**Ben Lusher - Online Submission from [REDACTED] (object)**

RE: Expansion of the existing Aged Care Facility at Sir Moses Montefiore Jewish Home,  
100-120 King Street and 30-36 Dangar Street, Randwick  
(MP09\_0188 and MP 10\_0044)

**Re: Application MP09\_0188 and MP10\_0044 - Expansion of the existing Aged Care Facility at Sir Moses Montefiore Jewish Home, 100-120 King Street and 30-36 Dangar Street, Randwick**

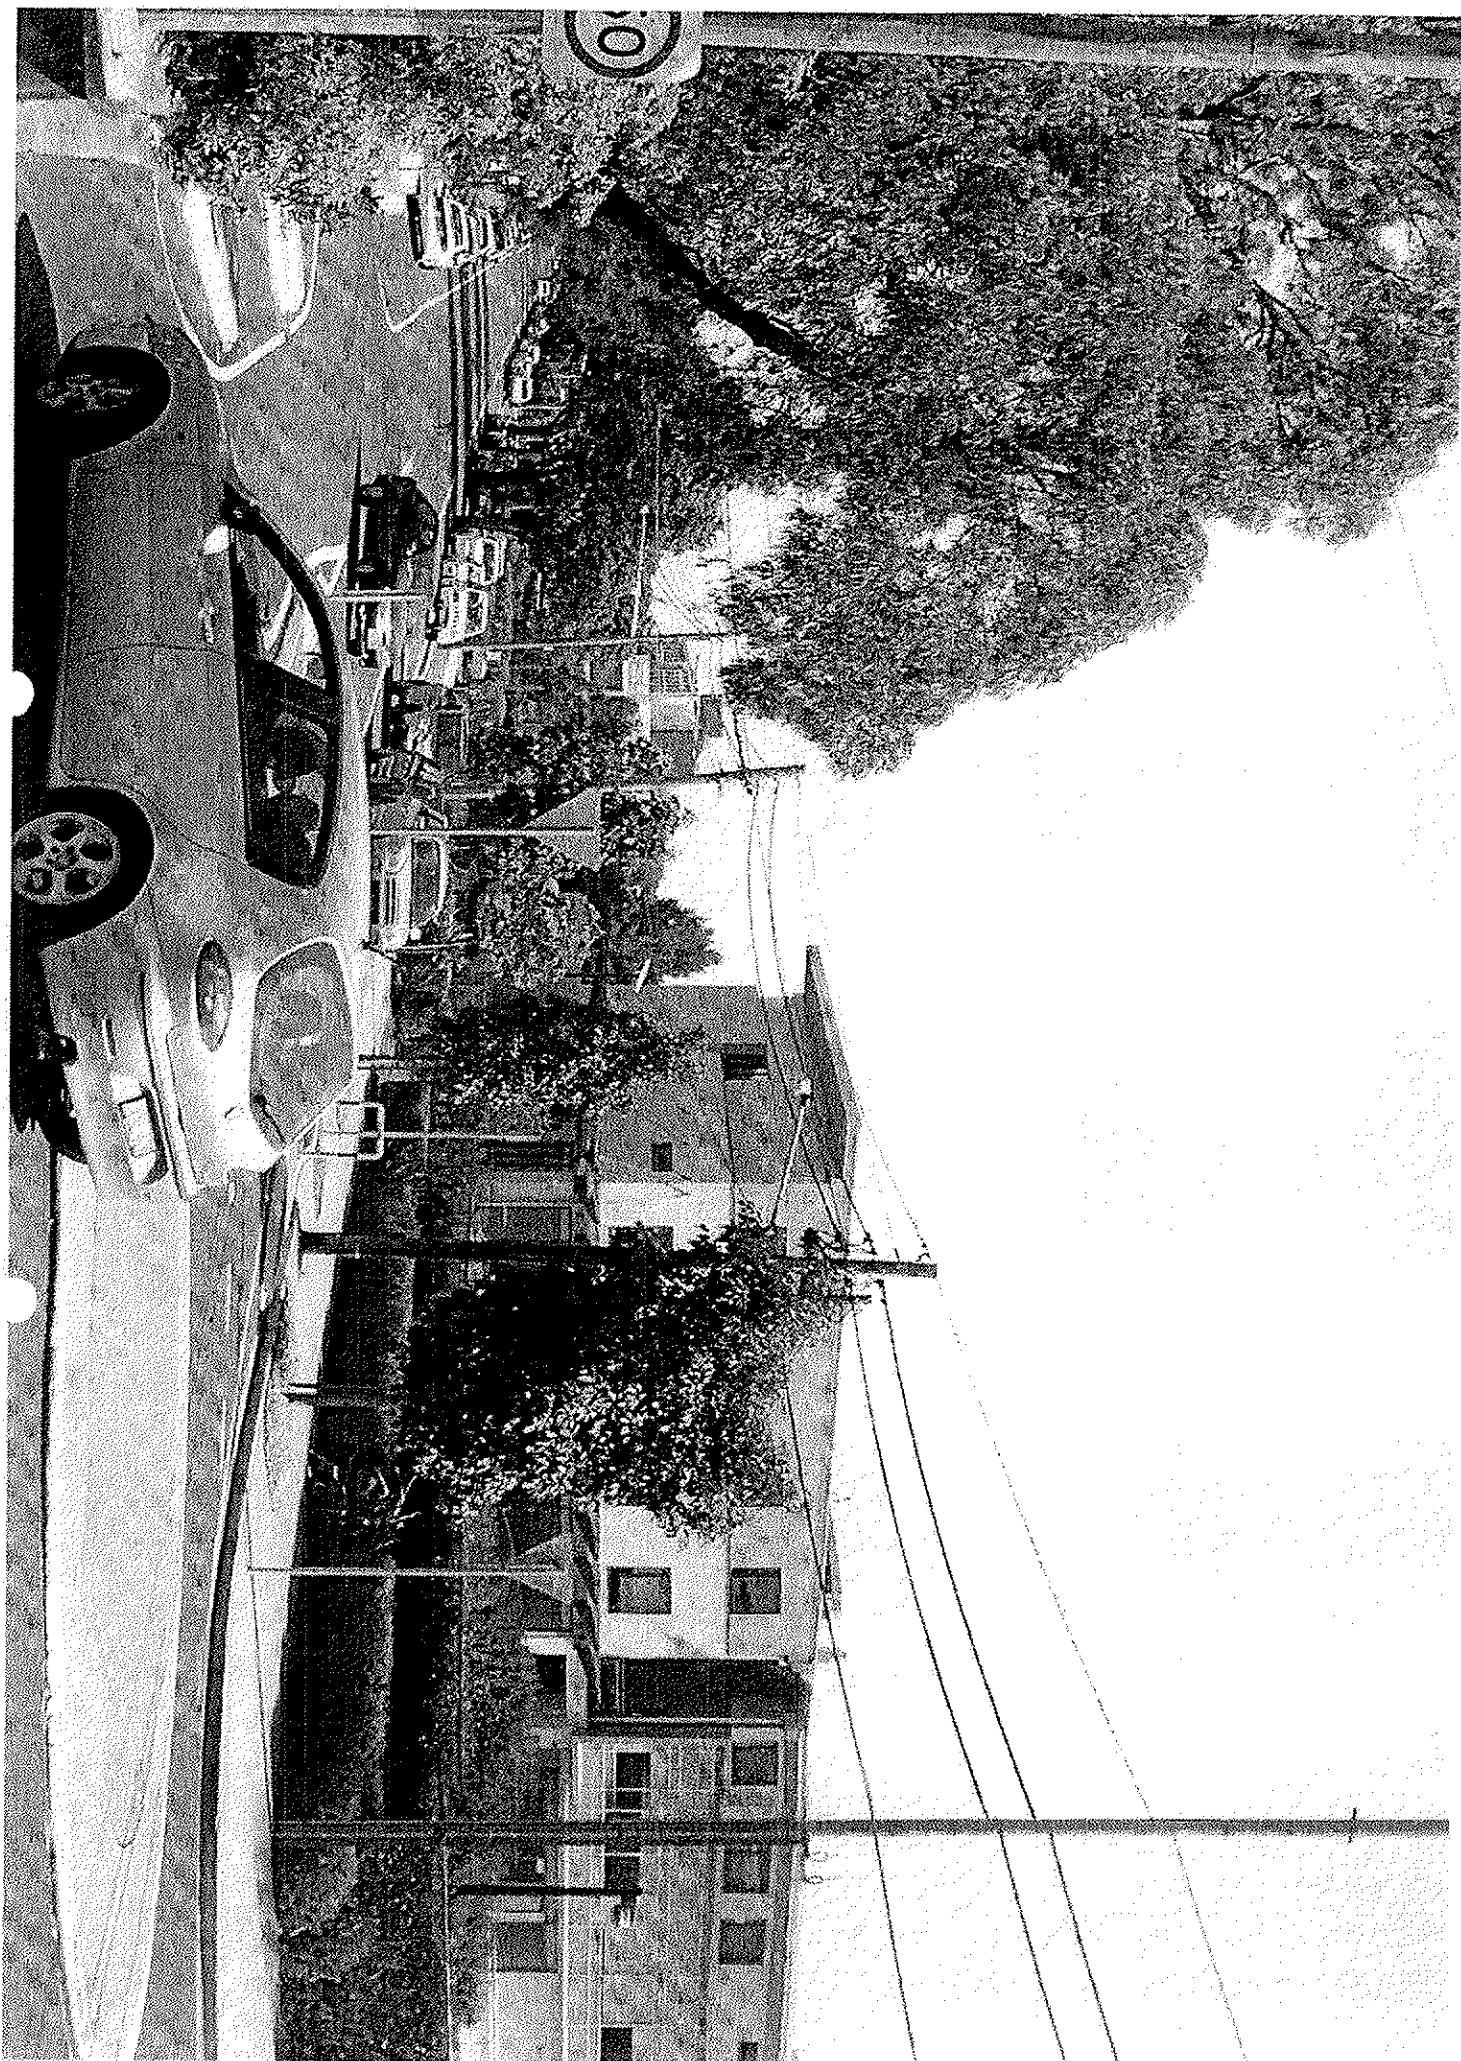
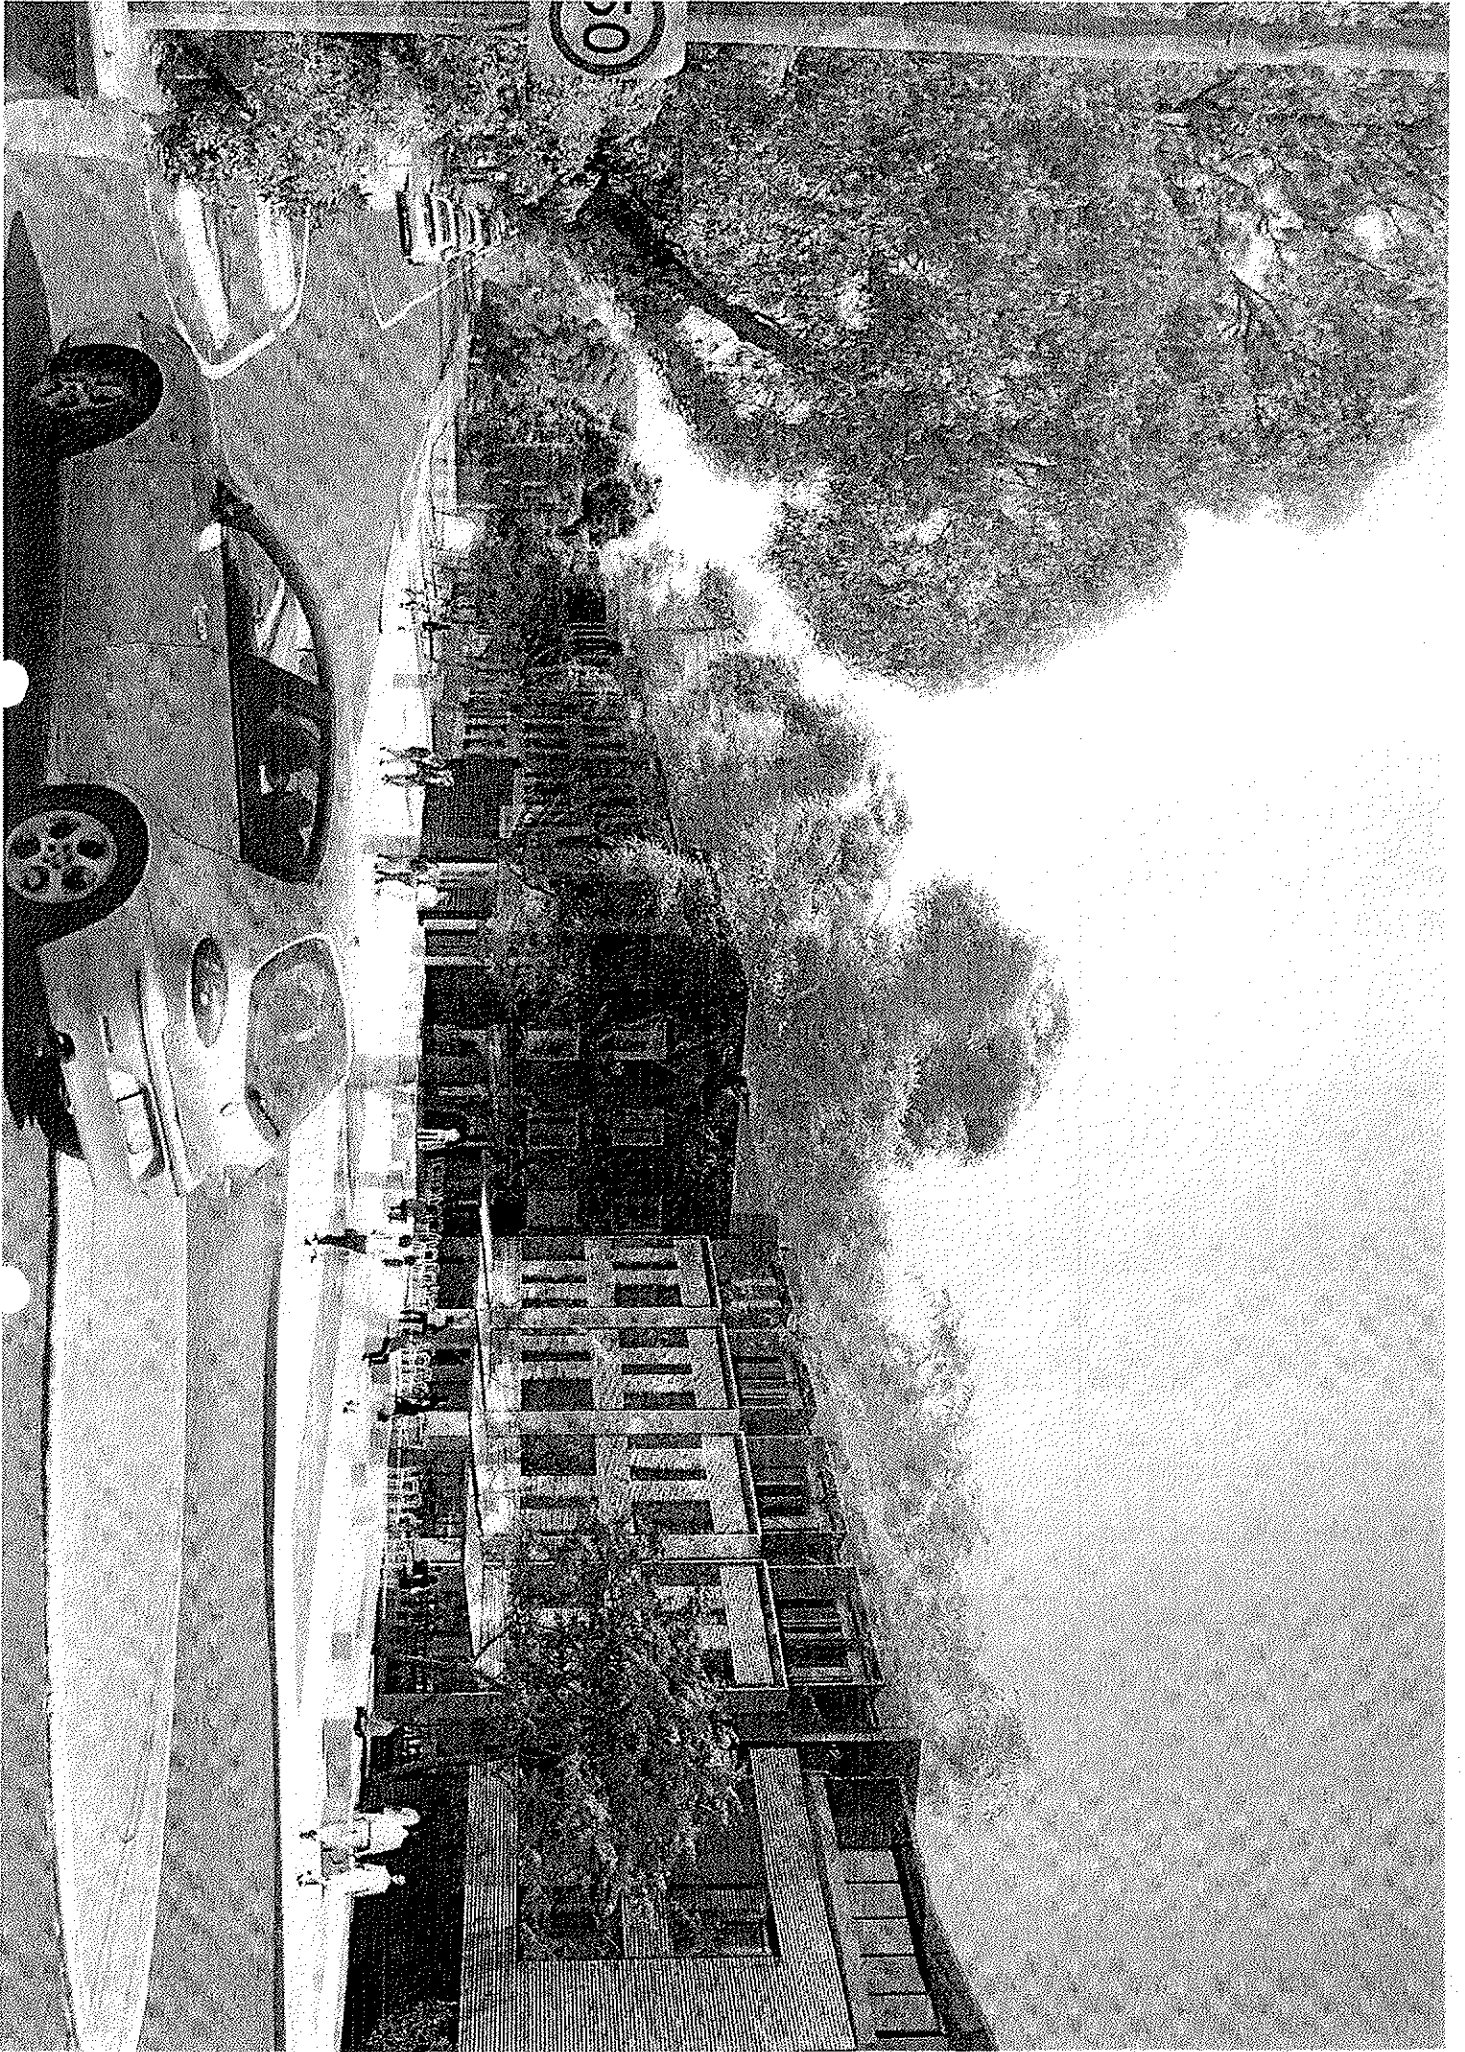
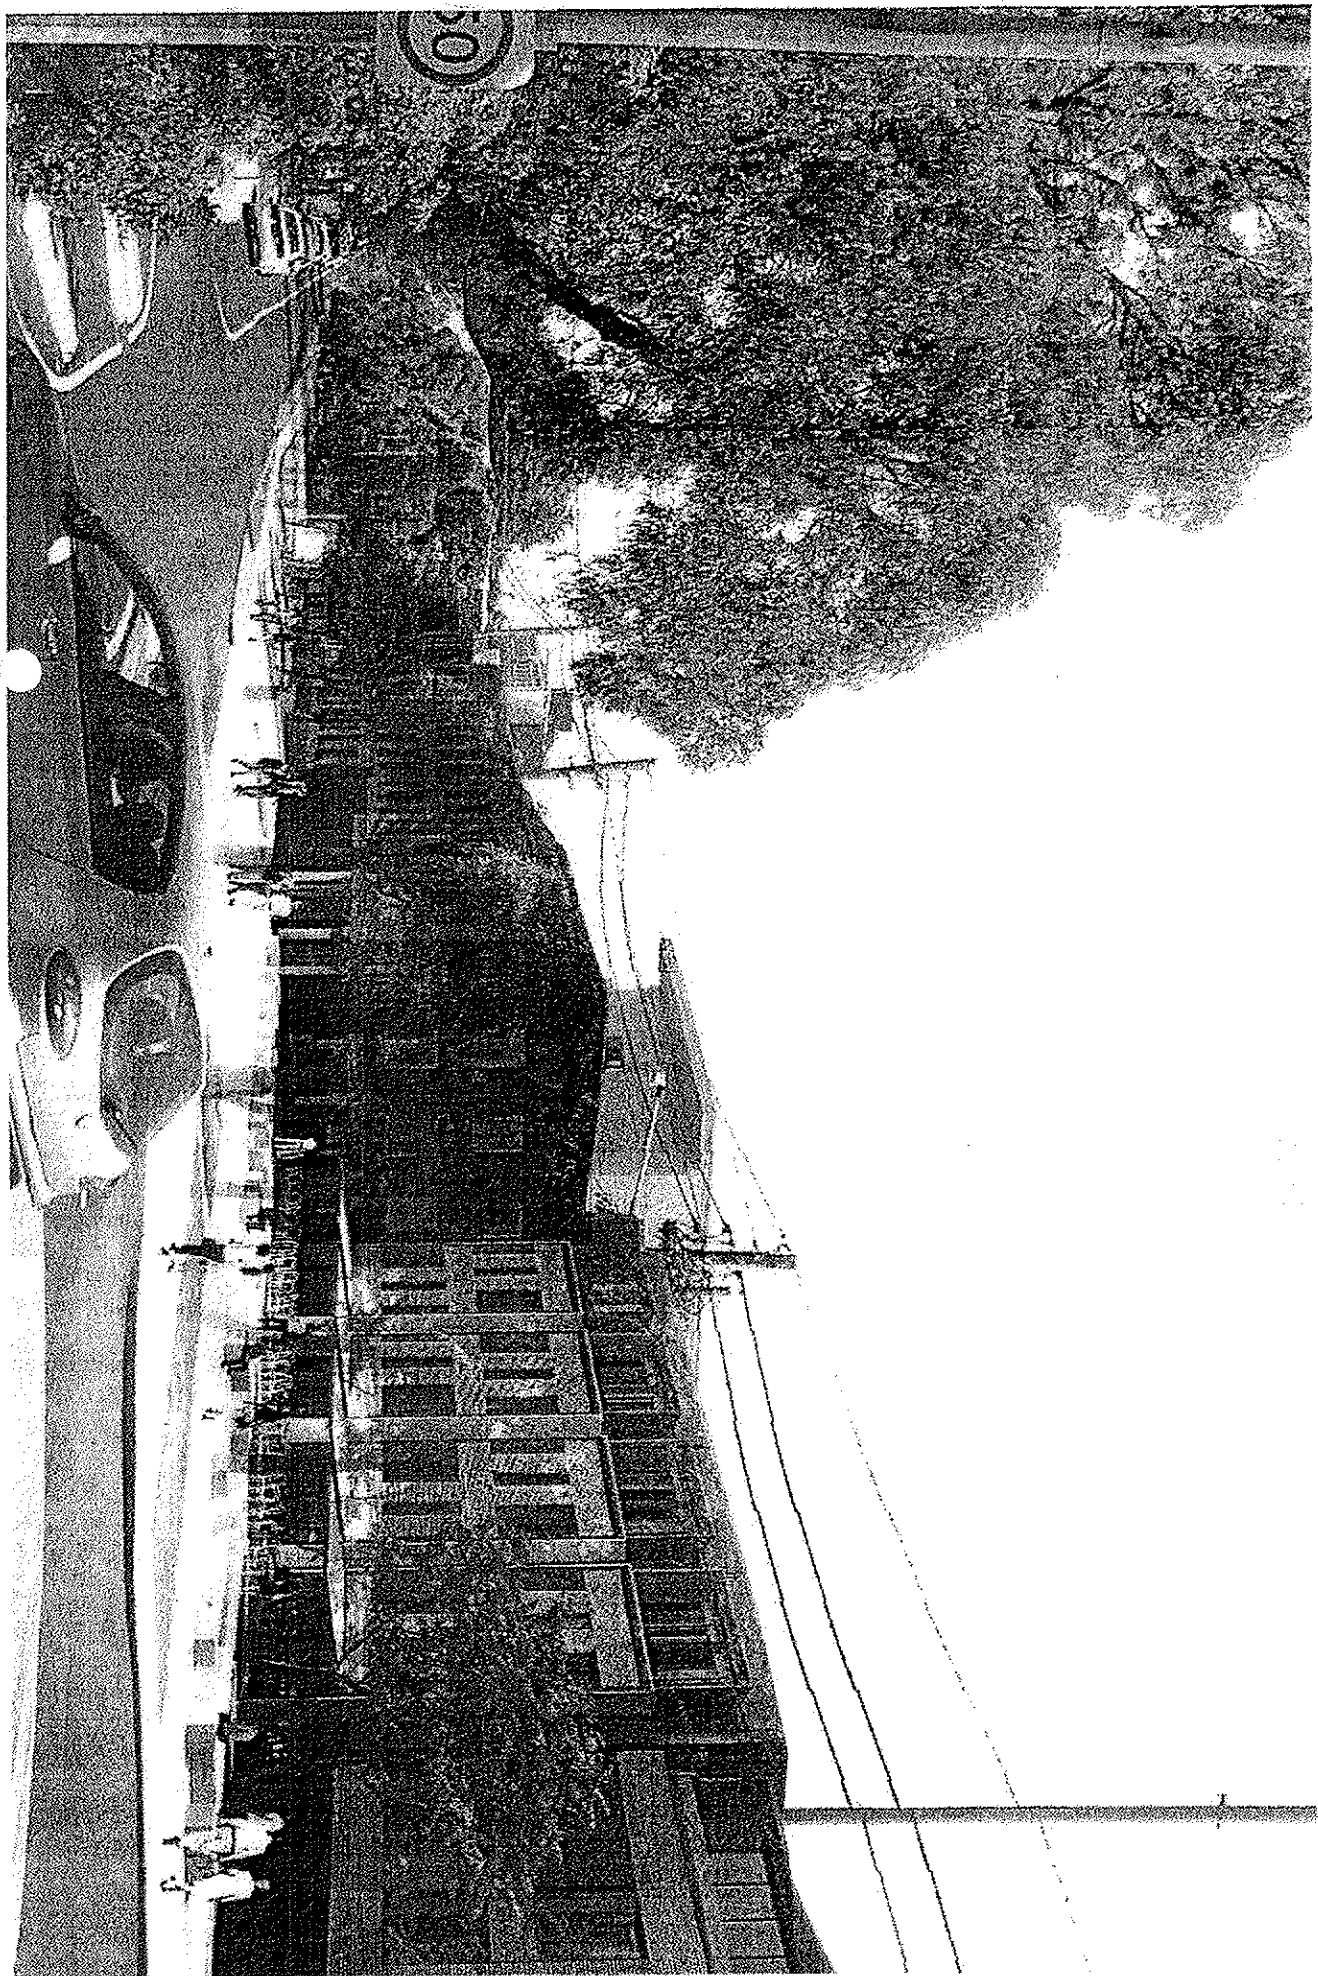
1. Appendix\_G\_Photomontages: Comparing the ?existing photo 1, View from corner of Dangar Street & King Street looking West along King Street? (Building C, Burger Centre) with ?photomontage 1, View from corner of Dangar Street & King Street looking West along King Street?: On both images, the orientation (south) and the scale of the car in front, roundabout and king street are identical. Copy and paste the proposed building over the existing building, it becomes clear that the photomontage is misleading. There is an additional story proposed on top of the Burger Centre (Building C), however, the photomontage shows the proposed building being considerably smaller than the existing Building C. . (Pls see PDF file Photo image 1\_ King Street)
